Shearwater Petrel 2/Perdix/Perdix AI/NERD 2/ Peregrine Firmware Release Notes

VERSION 93 2022-09-28

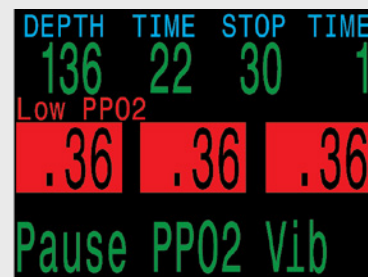
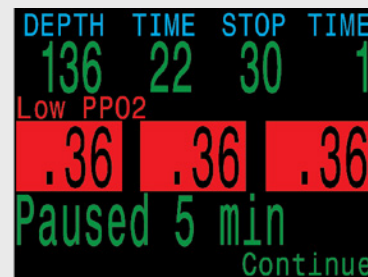
Continuous vibrating alarms for externally monitored (CCR) low and high PPO2 have been added.

Due to the critical importance of PPO2 levels in a closed-circuit rebreather, externally monitored PPO2 alarms will continue to vibrate every 10 seconds, even after the message has been acknowledged, as long as the alarm condition remains.

A “Pause PPO2 Vib.” Menu option will be available while a PPO2 vibrating alarm condition is active. This will pause PPO2 vibrating alarms for five (5) minutes. During this time other warning conditions will still cause vibrations.

When a Low or High external PPO2 alarm exists, the vibrating alarm will continue even after the Warning message has been cleared.

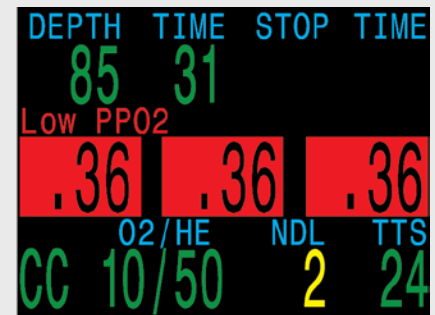
While such vibrations are active, a menu option will be available to Pause PPO2 Vibrations

This will pause vibrations for 5 minutes

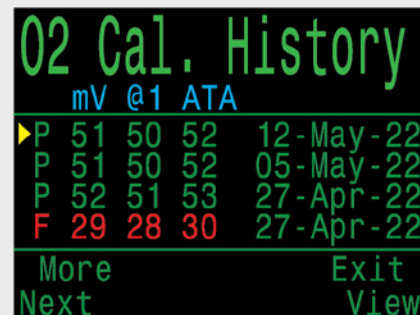
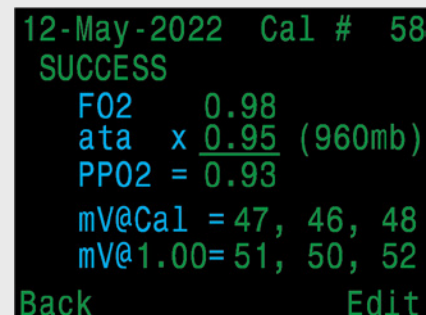
Displays a history of PPO2 calibrations. A log browser shows the date, status, millivolt (mV) levels, and input parameters for all PPO2 calibrations.

Note that the mV levels are shown in the history browser as if they occurred at a PPO2 of 1.0 ata. This allows calibrations done under varying conditions to be compared. For example, say a calibration is performed with 100% FO2 calibration gas 1.0 ata ambient pressure (so a PPO2 of 1.0 ata) and results in a reading of 50 mV. This same sensor, if calibrated with 100% FO2 at an altitude corresponding to 0.90 ata ambient pressure (PPO2 of 0.90 ata) would output only 45mV. In the history browser, both calibrations would show as 50mV to allow direct comparison of the sensor status. If the details are viewed, then the actual mV at calibration is also shown.

A history of PPO2 calibration results can be viewed

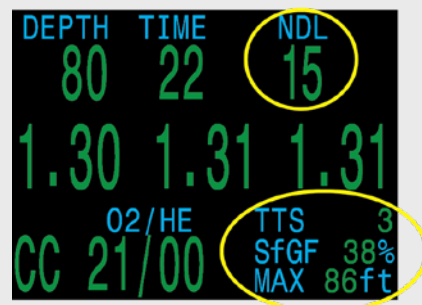
The “NDL Display” setting can be set to “Mini”. The Mini display can be configured to show 2 custom values, in addition to TTS which is fixed. The main display is slightly changed, with NDL moving up to the top right where DECO STOP is normally shown. NDL will show here until deco stops are needed, at which time it will change automatically to show deco stops.

A MINI display be chosen as the NDL Display setting

This option will move NDL up to the DECO STOP area. Once deco stops are needed they will replace the NDL.

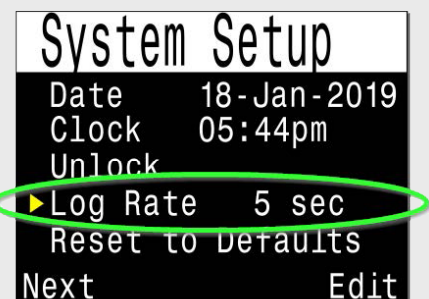
Surface GF is the gradient factor if you were to instantly ascend to the surface

Log Rate can be set to 2, 5, or 10 seconds

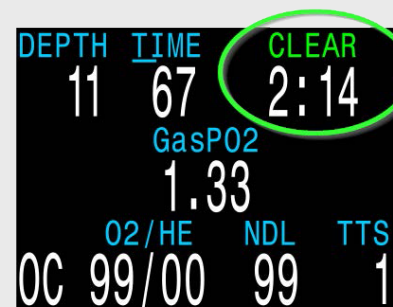
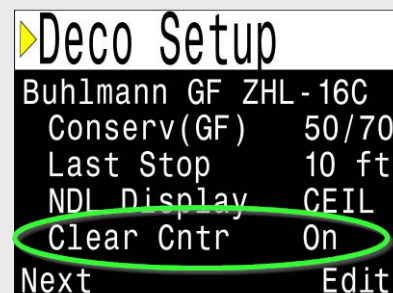
A “Deco Clear” up-counter option has been added.

The “Clear Counter” counts up once deco is clear

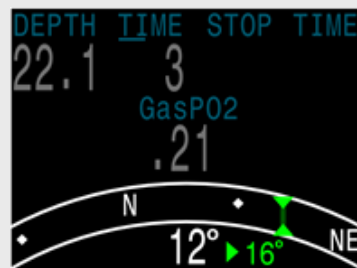
IMPROVE When a heading is marked, the display now shows the offset angle between the current heading and the marked heading. This is useful for navigating patterns. For example, a box pattern requires turns at 90° intervals, while a triangle pattern requires turns at 120° intervals.

The offset between current and marked heading is now shown (in this example 16°)
